# THE CORPORATION OF THE CITY OF WINDSOR COMMUNITY AND PROTECTIVE SERVICES -Planning

<b>LiveLink REPORT #: 13888 ZS/10256</b>	<b>Report Date: January 7, 2008</b>
<b>Author's Name: Adam Szymczak</b>	<b>Date to Council: January 19, 2009</b>
<b>Author's Phone: 519 255-6267 ext. 6447</b>	<b>Classification #:</b>
<b>Author's E-mail: aszymczak@city.windsor.on.ca</b>

**SUBJECT: SPC-032/08 – Petretta Construction Inc./2177314 Ontario Limited  
Southeast corner of Ouellette Avenue and Pitt Street West**

**FILE NO: SPC-032/08-1A (Site Plan)**

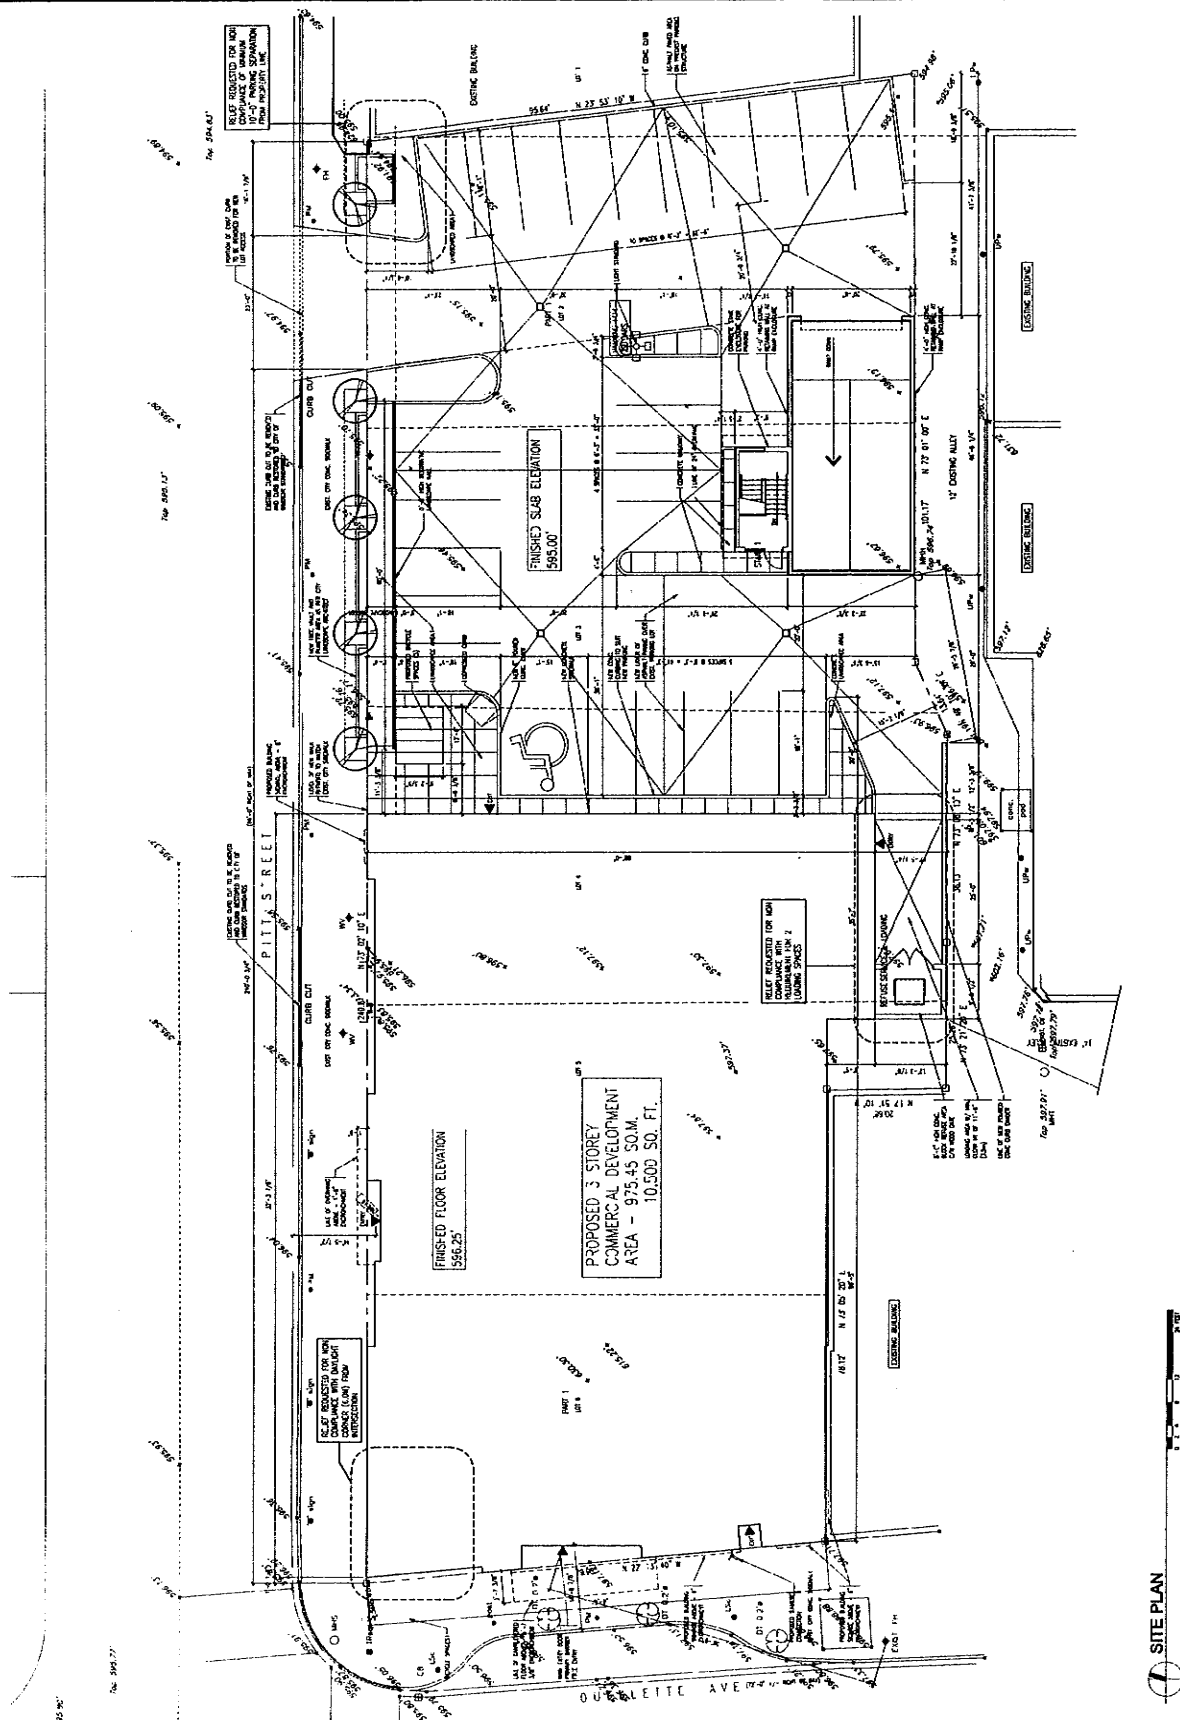
The recommended alternate site plan included a single access driveway to Pitt Street, a reduced landscaped parking area separation with additional landscaping in the boulevard sidewalk area, a parking lot screening wall along Pitt Street and a landscaped island at the northwest of the parking area that included bicycle parking spaces. The proposed change resulted in the loss of two surface parking spaces and a slight relocation of the emergency staircase from the underground parking garage.

Next, Mr. Petretta noted his opposition to the provision of the daylight corner. His client is adamant that it requires the number of offices shown on the floor plan. He pointed out that the window glazing would be clear, allowing people to see through the building, Mr. Petretta noted that the sidewalk area at the southeast corner of Ouellette and Pitt has a large area and is more than adequate to accommodate pedestrian traffic.

Staff appreciate Mr. Petretta's position, however, the purpose of the daylight corner provisions is to provide improved sightlines to motor vehicle operators, to improve pedestrian flow at intersections and to encourage developers to locate a main entrance that faces the intersection instead of the street. The daylight corner required by the Zoning By-law is not to be confused with the requirement for a corner cut-off land conveyance.

The complete elimination of the daylight corner – apart from its adverse impact in accommodating pedestrian congregation and flow in a relatively tight urban location and its effect on present and future vehicular traffic sight lines – does not "encourage the height, form, massing and articulation of new buildings at prominent locations to reflect their street position within the context of the overall block" (Official Plan 8.7.2.11).

It is the position of the Planning Department that the building as proposed by the applicant does not comply with the Official Plan.

**Administration opposes the complete elimination of the daylight corner.** The purpose of the daylight corner is to improve sightlines to motor vehicle operators, to improve pedestrian flow at intersections and to encourage an owner to locate the main entrance to face the intersection instead of the street.

The applicant raises a valid point in that the sidewalk area at the southeast corner of Ouellette Avenue and Pitt Street has a large area that currently allows adequate pedestrian movement. At its widest point, the sidewalk is about 20 feet wide on Ouellette Avenue and about 12 feet on Pitt Street.

While there is currently sufficient area for pedestrian movement, roads, sidewalks and intersections are subject to change. There may be an increase in traffic volume and a right turn lane may be required to facilitate traffic movements. The provision of a daylight corner would allow the City to alter the intersection with little to no impact on pedestrian flow and would implement the urban design intent of Section 8.7.2.11 of the Official Plan.

**The Planning Department can support a reduction in the daylight corner from 6 by 6 metres (20 by 20 ft) to 3 by 3 metres (10 by 10 ft) provided the owner agrees to install and pay for streetscape improvements (sidewalk, curbs and street furniture only – does not include infrastructure such as street lighting, tree vaults, irrigation, etc) to Pitt Street.**

**Should City Council decide to approve the development as proposed by the applicant – including the reduction or elimination of the daylight corner (the exact amount must be indicated) - then the following changes to the administrative recommendations are suggested:**

I That the application by **PETRETTA CONSTRUCTION INC. (File No.: SPC-032/08)** permitting development in accordance with Map Nos. SPC-032/08-1A (Site Plan), SPC-032/08-1B (Site Data), SPC-032/08-2A (Parking Level Plan), SPC-032/08-3A (North and South Elevations), SPC-032/08-3B (Enlarged Partial North Elevation), SPC-032/08-3C (East Elevation) and SPC-032/08-3D (West Elevation) **BE APPROVED CONDITIONAL ON** approval by the Committee of Adjustment of any minor variances.

B. Delete Clause 14 Corner Cut-off from Recommendation II
